SERVICE BULLETIN

SUBJECT: PSIO to CCM Wiring

NUMBER: C9814

MODELS AFFECTED: 19XR Chillers with O2XR5 Compressors

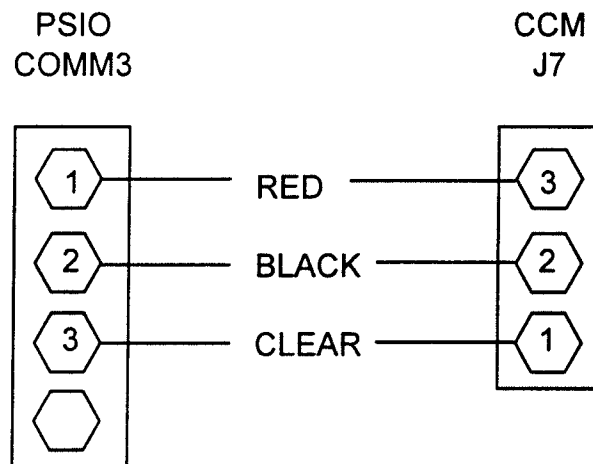
The wiring shown on the wiring diagram mounted on the machine is correct. The CCM does not follow "normal" SIO convention. On the PSIO (COMM3), J8-1 is positive and J8-3 is negative. On the CCM, J7-1 is negative and J7-3 is positive. The PSIO to CCM SIO bus should be wired as shown below.

The DIP switch settings for the CCM should be as follows:

Switch No.	1	2	3	4	5	6	7	8
Position	ON	ON	ON	ON	OFF	ON	OFF	ON

If the dip switches are wrong or if the communication wires are reversed, the compressor will not start and the message "Protective Limit - Diffuser Position Fault" will be displayed.
